**Subject: RESPONSE TO REQUEST FOR ADDITIONAL INFORMATION FOR  
THE RIO ALGOM LLC'S APPLICATION FOR GROUND WATER  
ALTERNATE CONCENTRATION LIMITS DATED JANUARY 16,2003**

**Corrective Action Program and Alternate  
Concentration Limits Petition for  
Uppermost Bedrock Units  
Ambrosia Lake Uranium Mill Facility  
Near Grants, New Mexico**

**Application for Alternate Concentration Limits in  
the Alluvial Materials at the  
Quivira Mill Facility  
Ambrosia Lake, New Mexico**

Figure 1. Sensitivity analysis using the midrange of each parameter for initial model input and then varying each parameter across its range one parameter at a time.

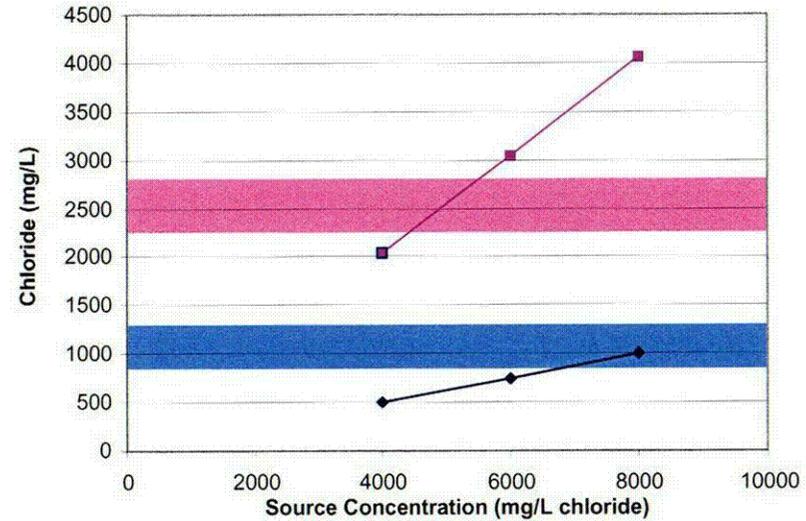
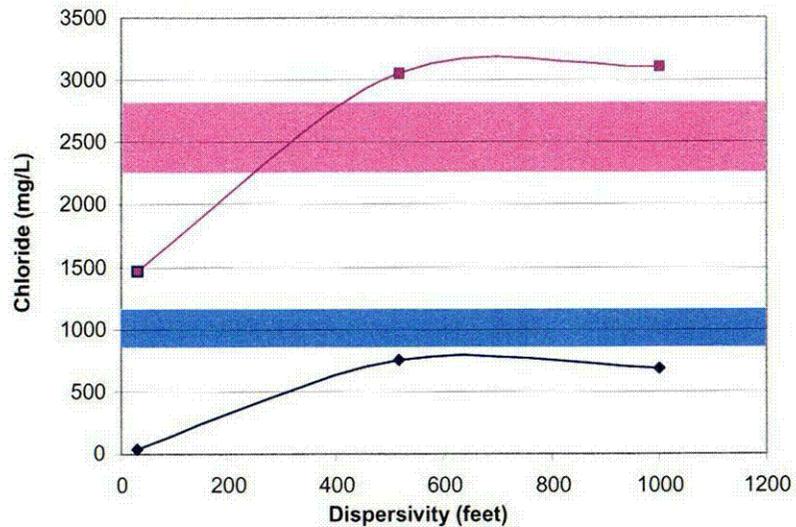
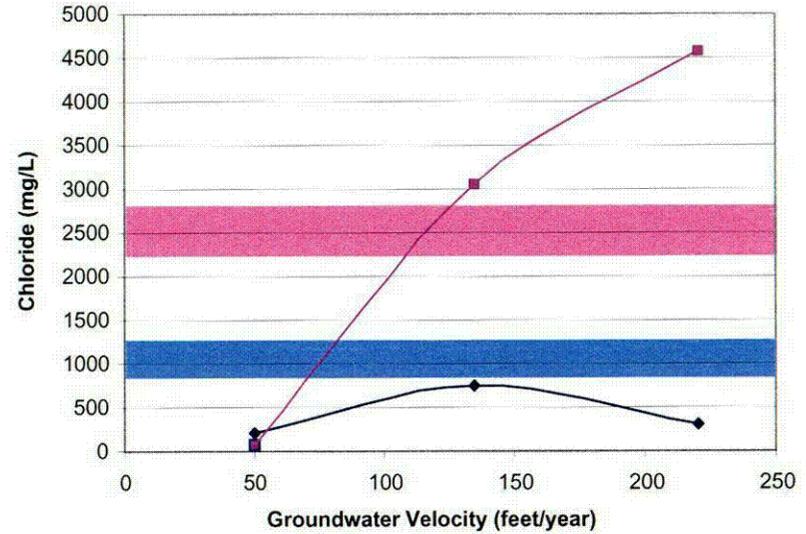
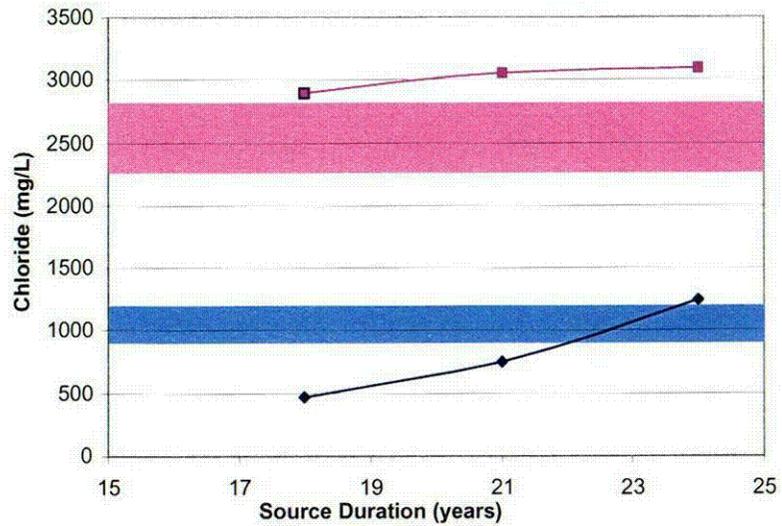
Using the SOLUTE code (Beljin and van der Heijde, Version 2.00, 1993) transport model results to estimate attenuation factors between point of compliance (POC) and POE locations seems reasonable; however, the effect of parameter uncertainty on the calculated attenuation factor has not been evaluated.

**REQUIRED ACTION:** Rio Algom should provide an uncertainty analysis for the calculations used to estimate contaminant attenuation factors. Documentation of these analyses should include the range of attenuation factors that can be estimated from a set of transport calculations that can be reasonably calibrated to match observed chloride and U-nat concentrations, considering the uncertainty in groundwater velocity, dispersion lengths, uranium retardation factor, and source concentration variability. It should be shown, based on this uncertainty analysis that the attenuation factors used to calculate proposed health-based ACLs are reasonable and not overly optimistic. As part of this analysis, provide an explanation for the recent trends at well 36-06KD (i.e., rising chloride and U-nat, and descending pH).

The sensitivity analysis consisted of choosing the midrange of each parameter for initial model input and then varying each parameter across its range one parameter at a time. Other parameters were held constant at the midrange during each model run. Figure 1 presents the results of the sensitivity analysis for each parameter along with concentration targets for POC well 36-06KD and POE well 36-04KD. Calibration targets were developed from the range of concentrations observed in those wells during the 1992 to 1994 time period (years 31-33 from the start of the model). Results show that the best fit for all parameters is closer to the middle of each range, rather than at any extreme. Model results are relatively insensitive to variations in some parameters (specifically source duration and dispersivity above 500 feet) while calibration targets can only be matched in a narrow range for others (specifically groundwater velocity and source concentration). Therefore, statistical goodness of fit analyses were not considered necessary. The final optimized model for chloride transport (Figure 2) used the following values:

Figure 4. Eh-pH Diagrams for the Constituents of Concern in Groundwater from the Dakota Formation, Rio Algom Site, Ambrosia Lake, New Mexico. Diagrams from Brookins (1988).

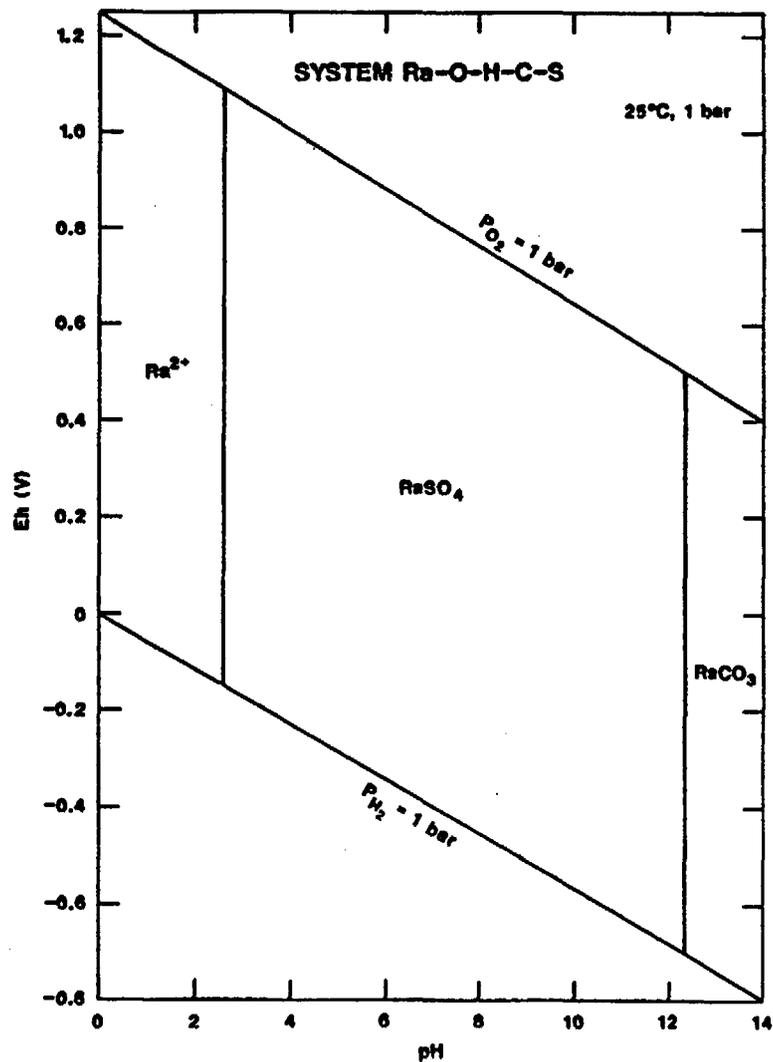
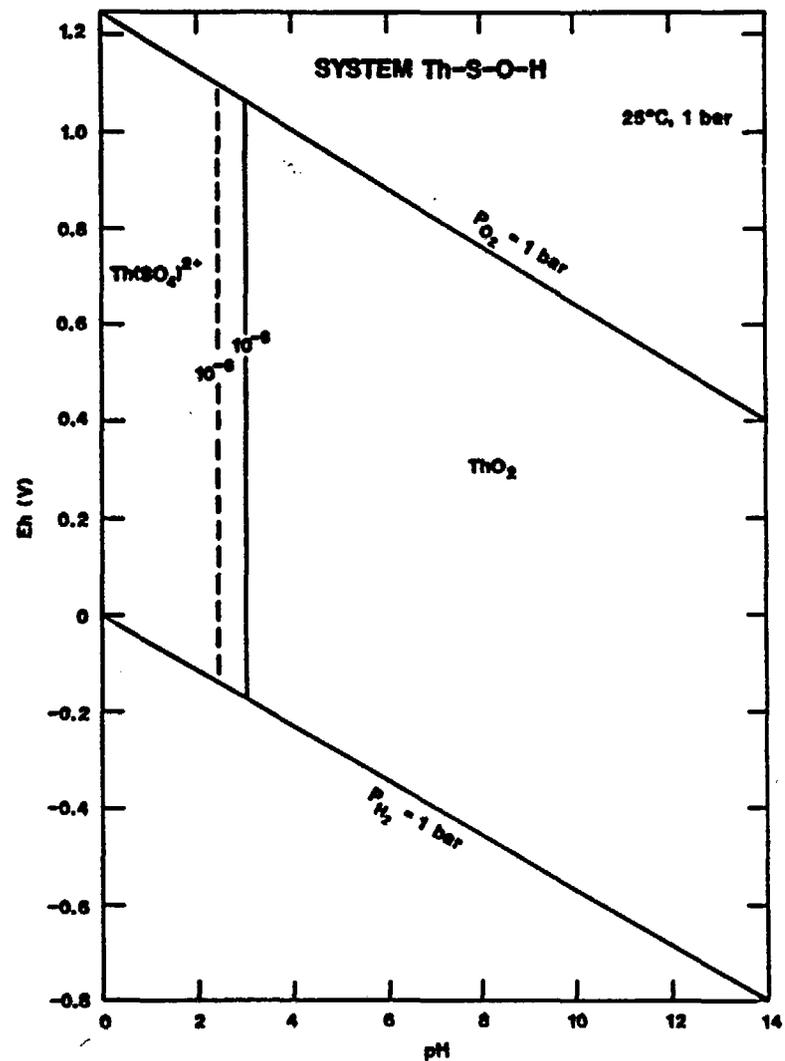
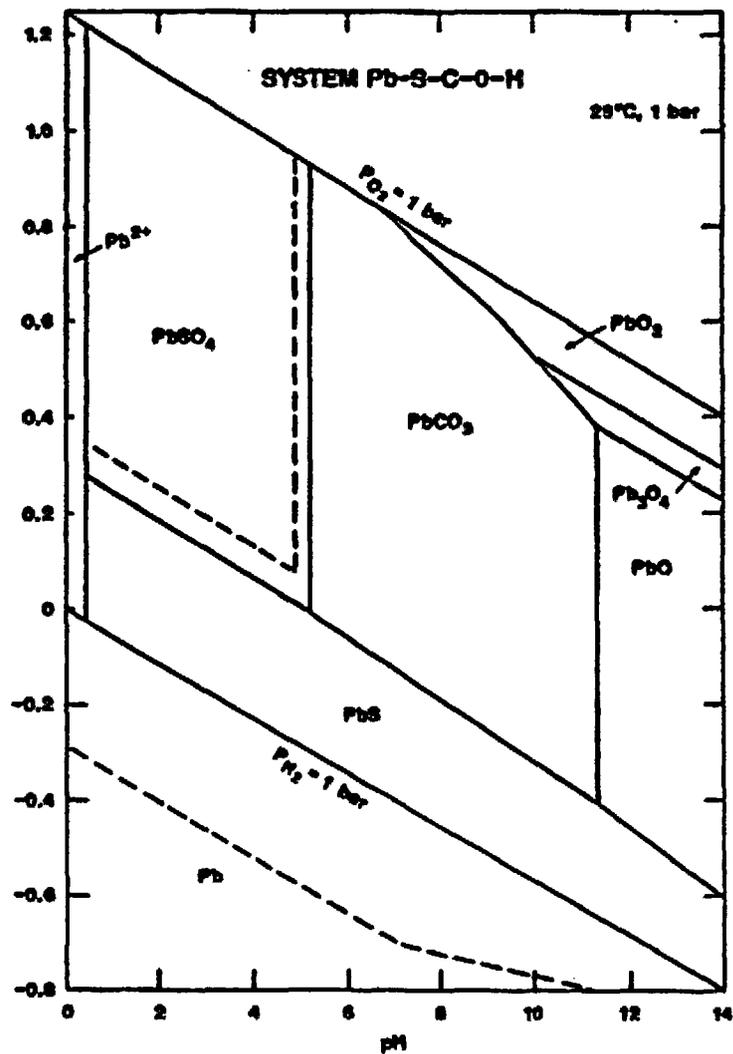
A basis is required for the assertion that applying the uranium attenuation factor to all other contaminants is conservative because uranium is the most mobile of the group.

**REQUIRED ACTION:** Provide the technical basis for the assertion that “U-nat is the most mobile of the hazardous constituents of concern” (bedrock aquifer application, p. 2-34).

Eh-pH diagrams from Brookins (1988) (Figure 4) provide a framework for understanding data trends in monitor well 36-06KD. Note that all constituents of concern are in solutions as cationic species at the low pH's expected in acid leach tailings solutions. At low pH values, negative sorbent surfaces in the aquifer matrix are saturated with positive charge from  $H^+$  in solution. Under these conditions, cations are not adsorbed and travel with chloride at roughly the same velocity as groundwater flow. As the solution becomes more neutral, cations, with less competition from  $H^+$  ions, are increasingly adsorbed. Therefore, concentrations of constituents of concern decrease as the pH rises. However, note that radium, thorium and lead tend to precipitate as solid phases as the pH rises (Figure 4c, 4d, and 4e). Radium and thorium are soluble only below a pH of about 3 and lead is soluble only below a pH of less than 1. Concentration-limiting solids change the transport characteristics of radium, thorium, and lead in groundwater, irreversibly removing some concentration of these constituents from solution.

In contrast, uranium and nickel have no concentration-limiting solid forming as the pH rises. As a consequence, these constituents can be expected to be more mobile than

radium, thorium, and lead. Uranium is present as uranyl ion ( $\text{UO}_2^{2+}$ ) at low pH. Various uranyl carbonate complexes become the predominant uranium species in groundwater as the pH rises. The uranyl carbonate species are neutral or anionic, completely changing the transport characteristics of uranium in groundwater from those observed for uranyl ion. Nickel ion ( $\text{Ni}^{2+}$ ) is the dominant nickel species in solution below a pH of 9 (Rai and Zachara, 1984). As a result, nickel becomes increasingly adsorbed as the pH rises, which may cause the transport of nickel to be retarded relative to uranium, particularly in carbonate rich water.

Figure 8. Final optimized model for uranium transport in the Dakota

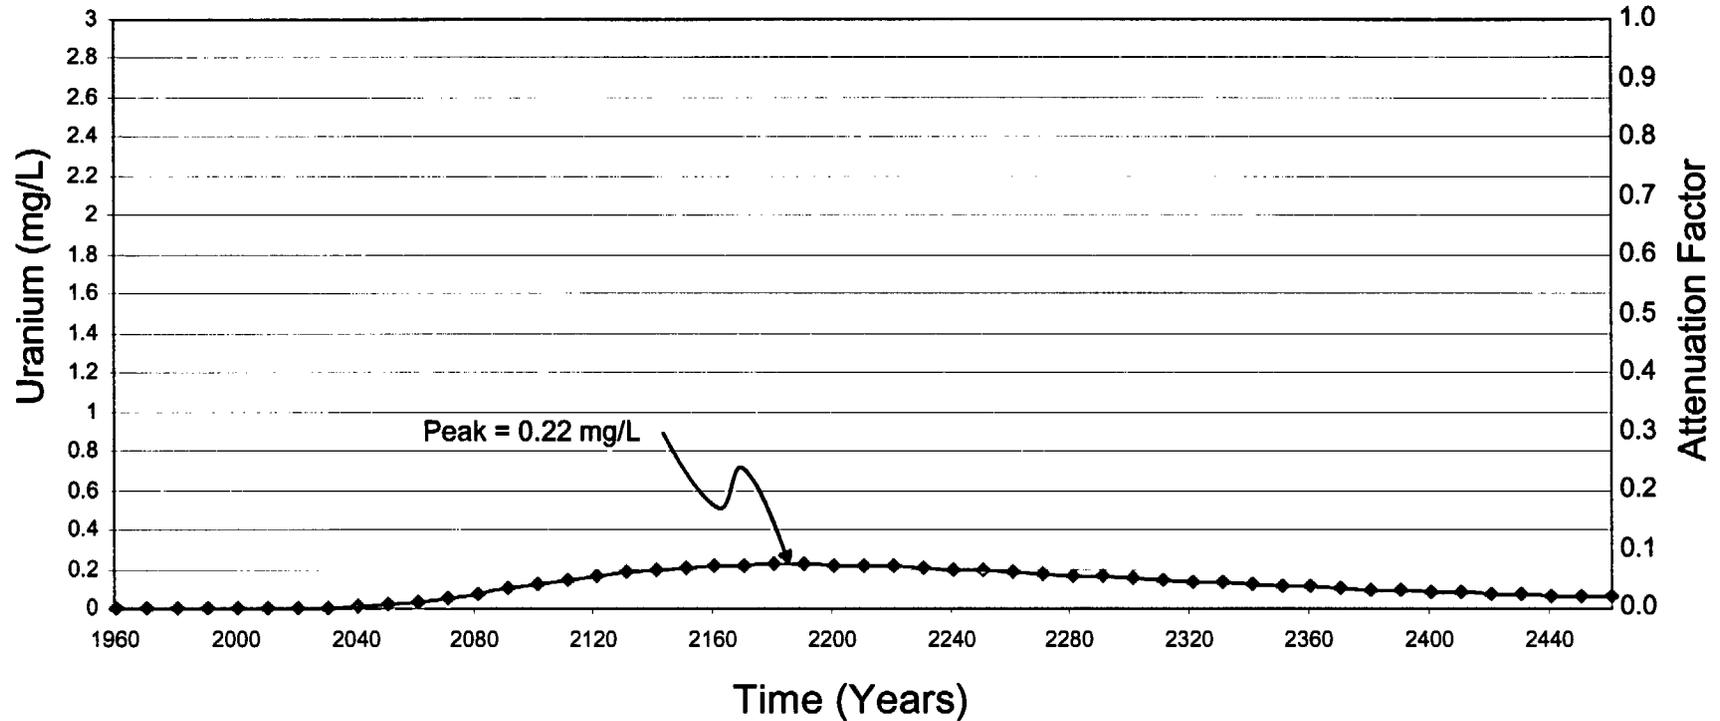
The NRC correctly points out that the source concentration used in the uranium transport model to calculate the 0.16 attenuation factor ignores early data that indicates that uranium concentrations have been as high as 8 mg/L. That circumstance occurred when the pH was below 4 (Figure 3h). While the pH has again dropped below 4 in the most recent data (for reasons that will be discussed below), the uranium concentration has not been reported above 1 mg/L. We interpret this as follows: early, very acid water (pH 1 to 3) could transport high concentrations of uranium, but higher pH water (pH 3 to 5) can transport lower concentrations (0.01. to 1 mg/L).

The transport behavior of uranium in the first 800 feet from the source to the POC well is very different than the behavior of uranium in the remaining 3,900 feet between the POC and the POE well. In order to develop a realistic estimate of attenuation it is necessary to make an estimate of the uranium concentration that could persist past the near source zone of low pH. A conservative approach to this problem uses the highest uranium concentration observed in more recent data at monitor well 36-06KD (1 mg/L), and adds a safety factor equal to twice the observed concentration, resulting in a model input of 3 mg/L. This input is modeled along the 3,900 foot flow path from POC monitor well 36-06KD to POE monitor well 36-04KD (Figure 8). This model results in an attenuation factor of approximately 0.07, which is less than one half of the attenuation factor used to set bedrock ACLs. Therefore, the attenuation factors used to calculate currently proposed bedrock ACLs are considered conservative, appropriate, and not overly optimistic.

Simplified Geologic Map of the QMC Site Showing Location of Vent Holes and Subcrop of the Tres Hermanos B Sandstone Beneath the Alluvium.

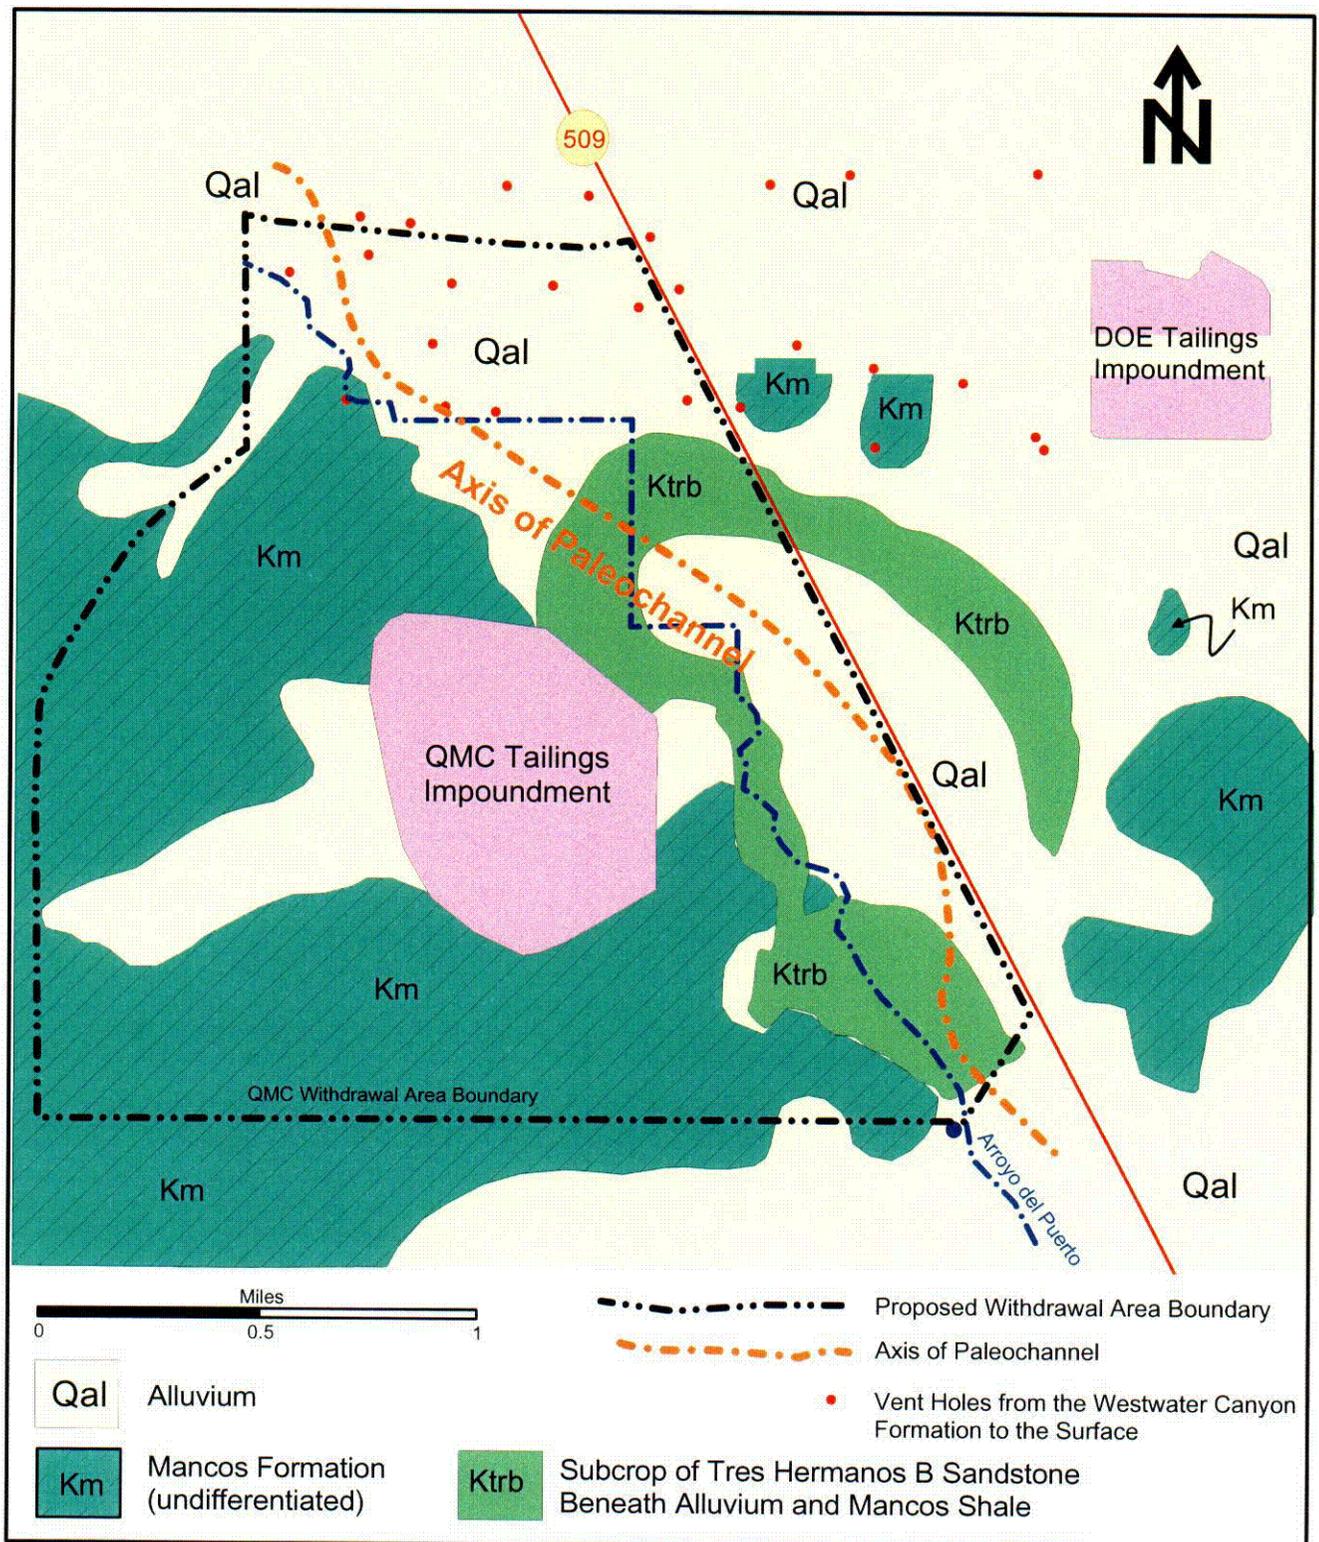
Much of the groundwater currently in the alluvial formation is expected to drain into the Tres Hermanos A (TRA) and Tres Hermanos B (TRB) bedrock units, but the application contains no discussion or analysis of fate and transport of contaminated alluvial-system drainage in the bedrock formations.

**REQUIRED ACTION:** Rio Algom should provide fate and transport assessments for constituents of concern entering the uppermost bedrock units as drainage from the overlying alluvial formations.

A simplified geologic map of the Rio Algom site showing the subcrop of the Tres Hermanos B is presented in Figure 9. Also shown are vent holes from the Westwater Canyon Formation to the surface. The transport of constituents from the Rio Algom site to the Tres Hermanos B will be along the following pathway: Constituents may originate at either the tailings impoundment or an unlined evaporation pond, infiltrate the Alluvium, move from the Alluvium to the Tres Hermanos B west of the Arroyo del Puerto bypass, move down dip in the Tres Hermanos B to the north and northeast (Bedrock ACL Application) where they will ultimately be contained by the hydrologic depression created by over 40 years of mine pumping in the valley.
